P&Z CASE # M152020-002 P&Z DATE 01/28/2020 CC DATE 02/18/2020 APPROVED/DENIED

SUBJECT: MIS2020-002; *Amended Treescape Plan for 3005 N. Goliad Street*

TREE PRESERVATION PLAN
MIXED-USE DEVELOPMENT
3005 N. GOLIAD ST
ROCKWALL, TEXAS

TREE PRESERVATION PLAN
 MIXED-USE DEVELOPMENT
 3005 N. GOLIAD ST
 ROCKWALL, TEXAS

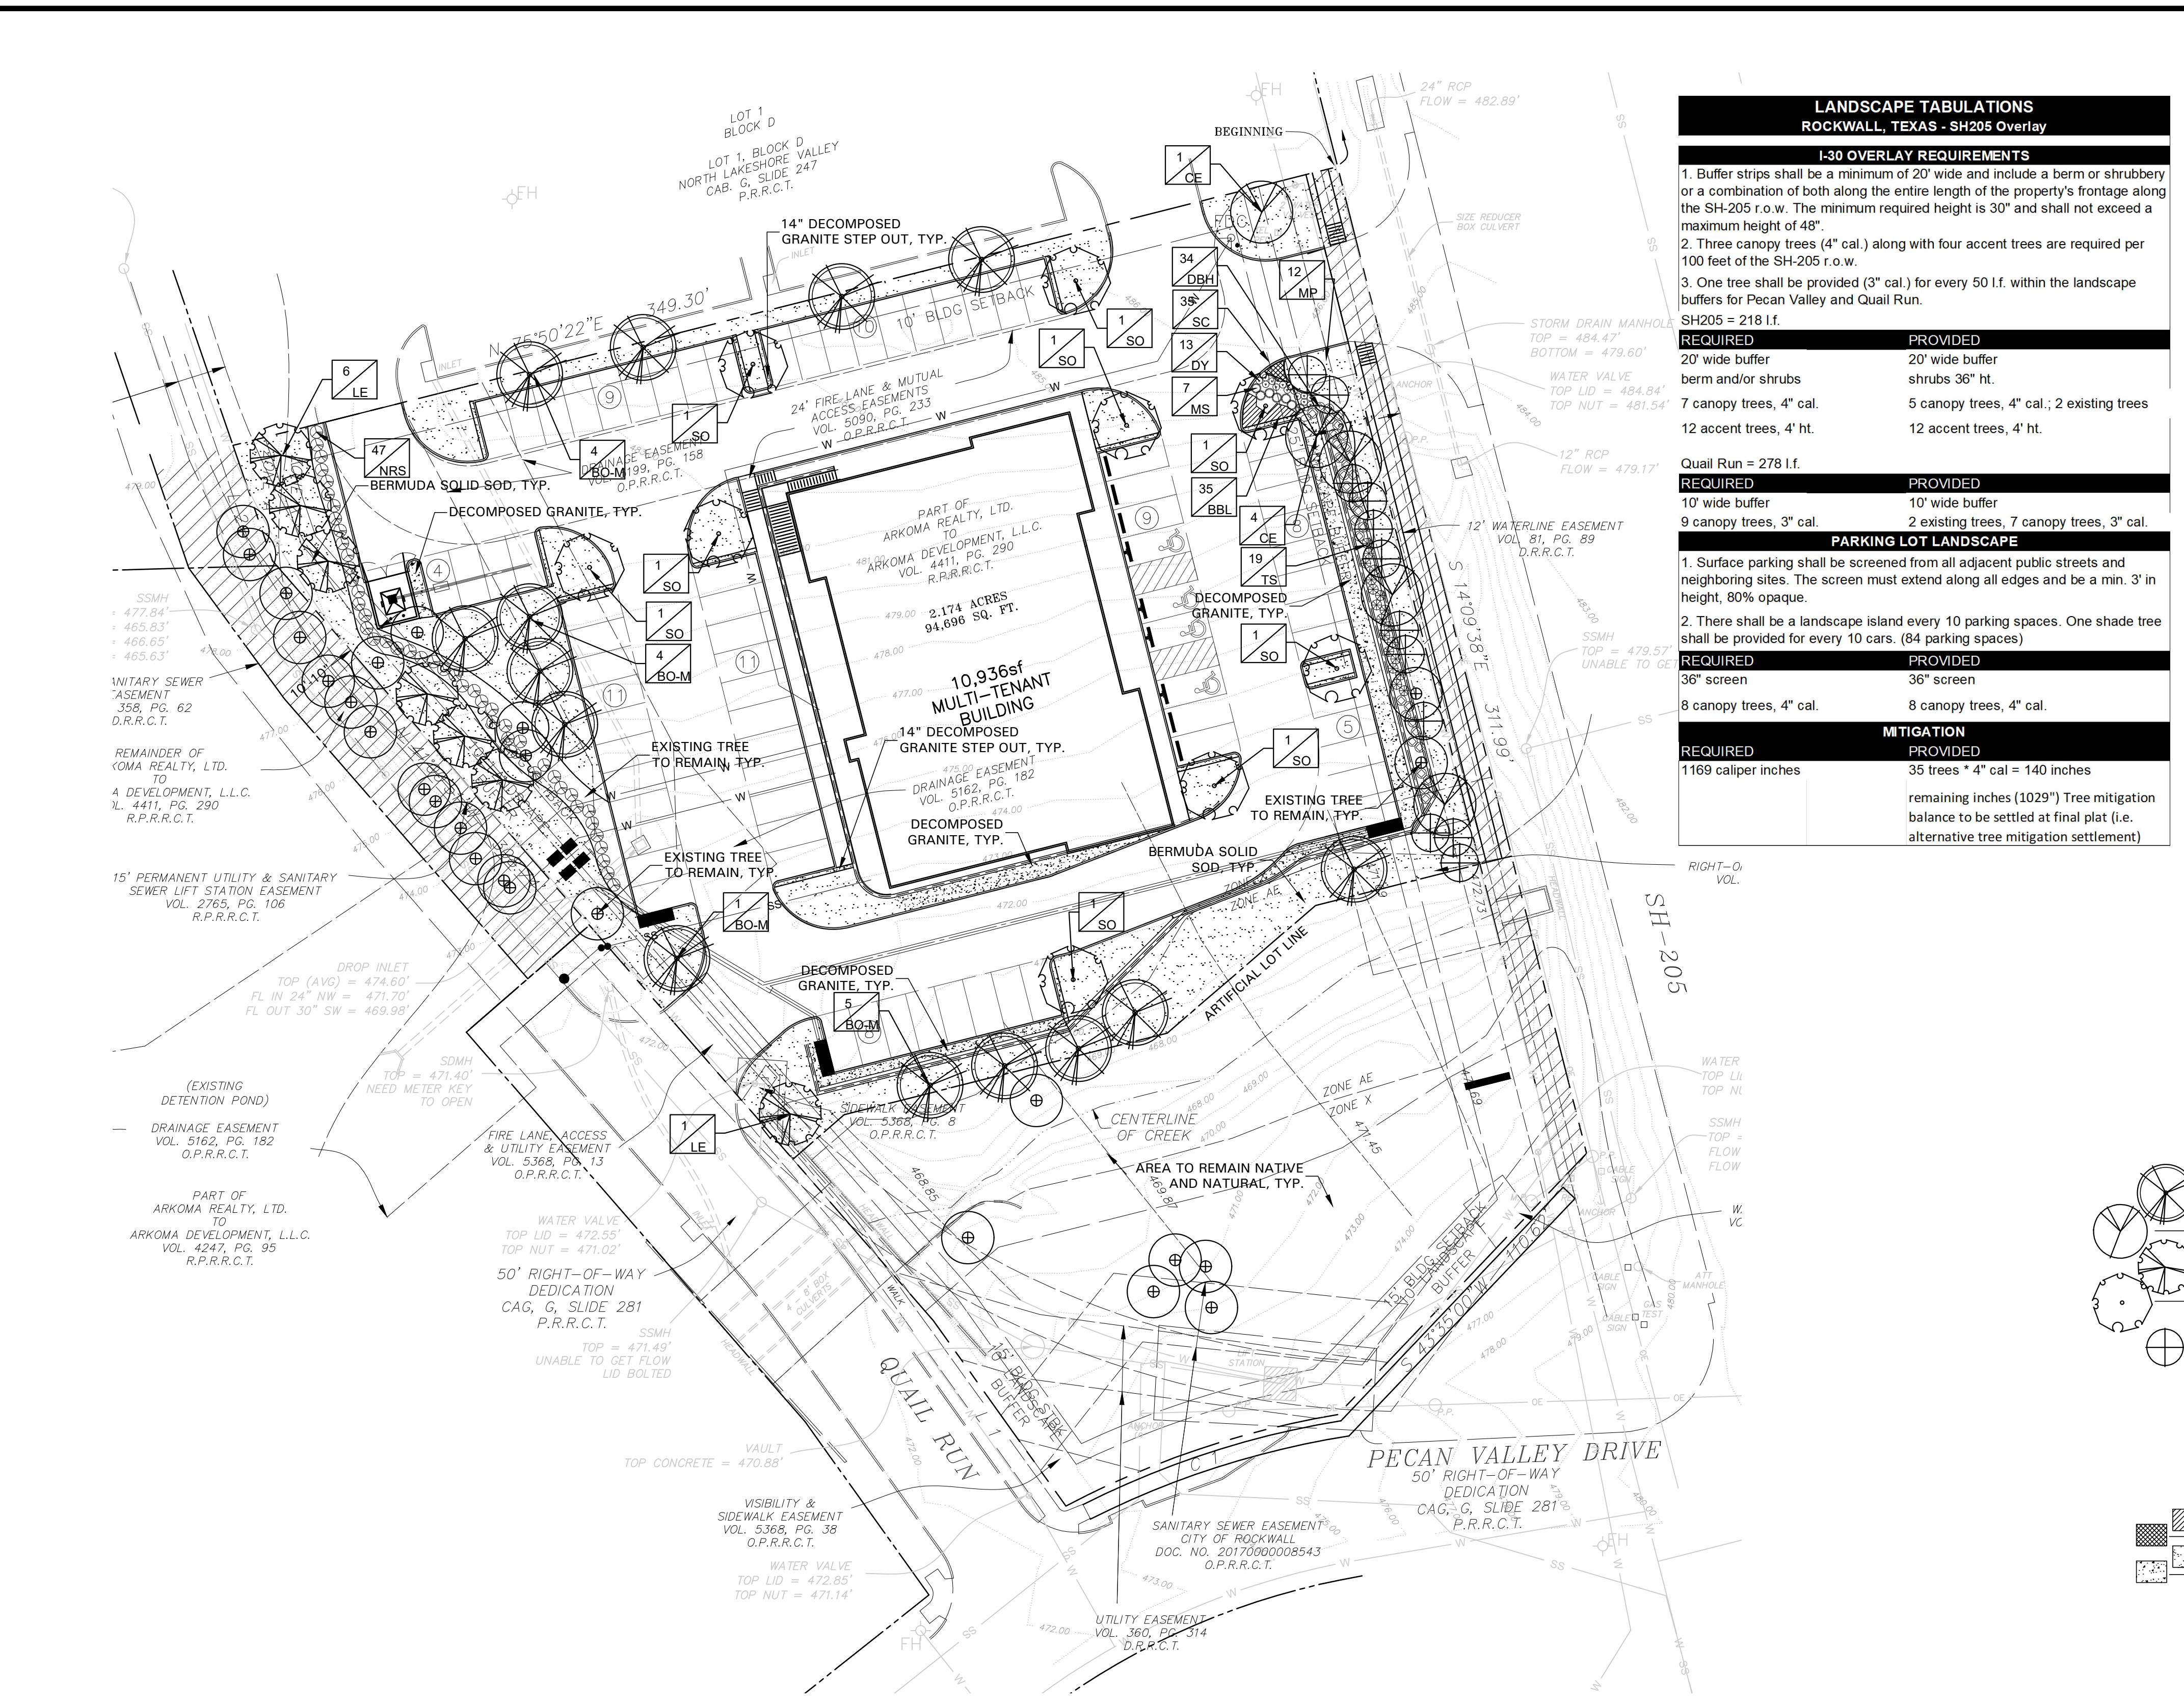
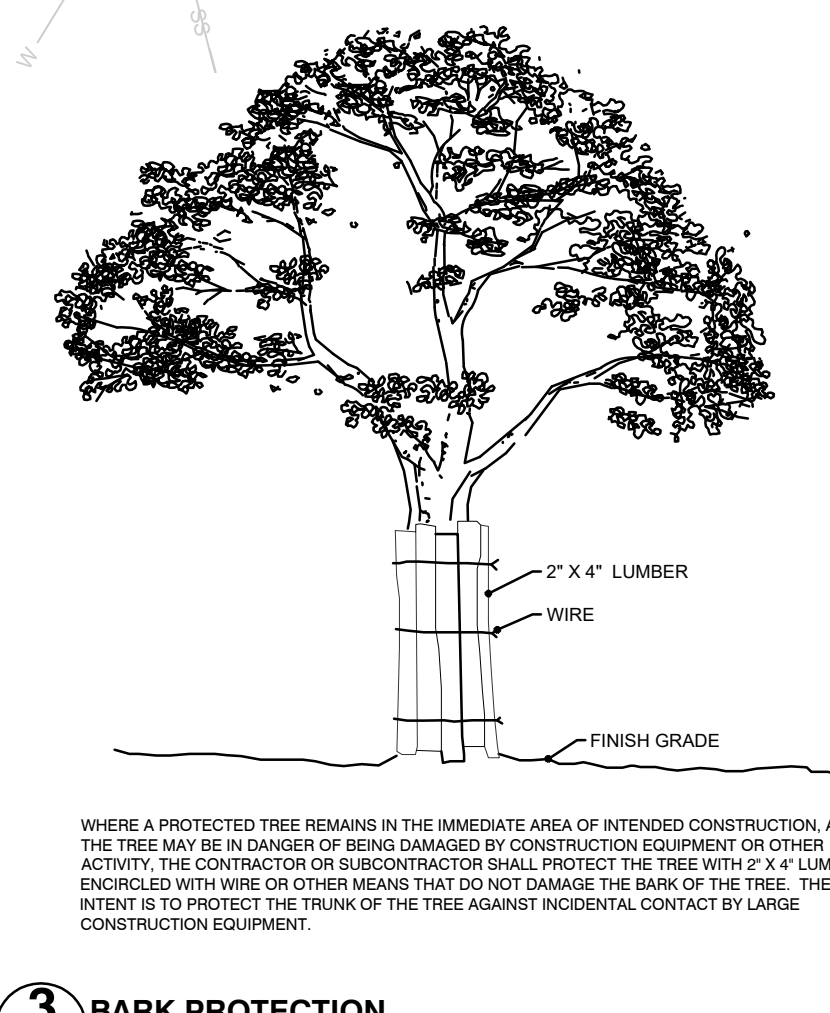
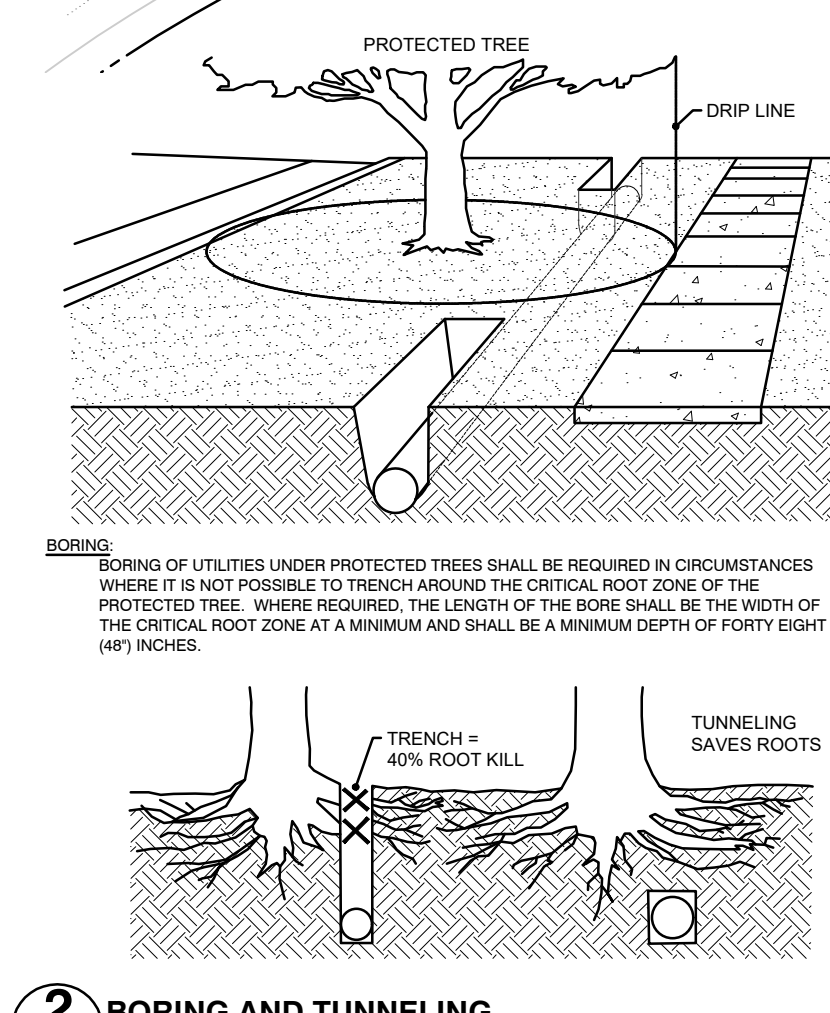
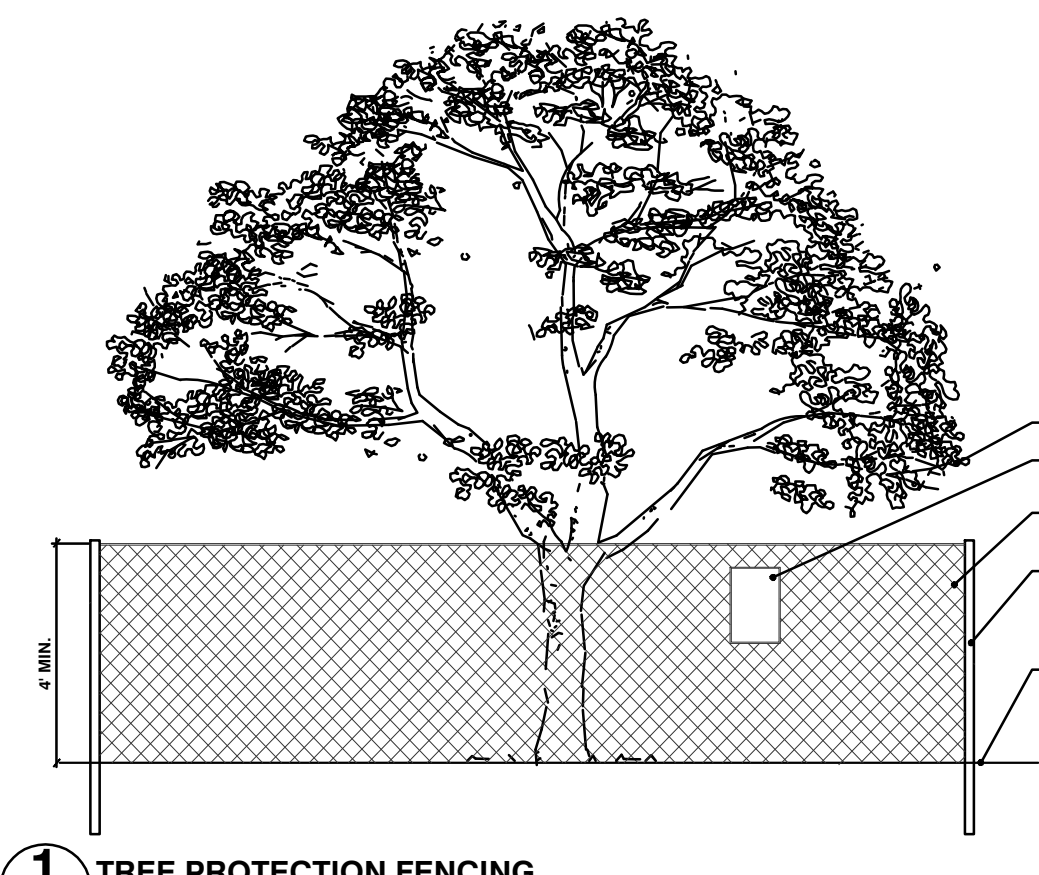
M.3						For reference, include the case number (MIS2020-002) in the lower right-hand corner of all pages of all revised plan submittals (i.e. Treescape and Landscape Plans).
I.4						This project is subject to all requirements stipulated by the Unified Development Code (UDC), the North SH-205 Overlay (N SH-205 OV) District, and the General Development Standards of Article V, that are applicable to the subject property.
M.5						Provide an updated treescape plan that represent a mitigation balance due of 1,155-caliper inches.
M.4						Provide an updated landscape plan that represents all the materials being planted [i.e. graphically and numerically in the legend of the plan] meeting the Landscape Standards of Article 08 of Unified Development Code and the General Development Standards of the N SH-205 OV regarding landscape materials.
I.5						The Planning and Zoning Work Session will be held on January 28, 2020.

Case#: MIS2020-002
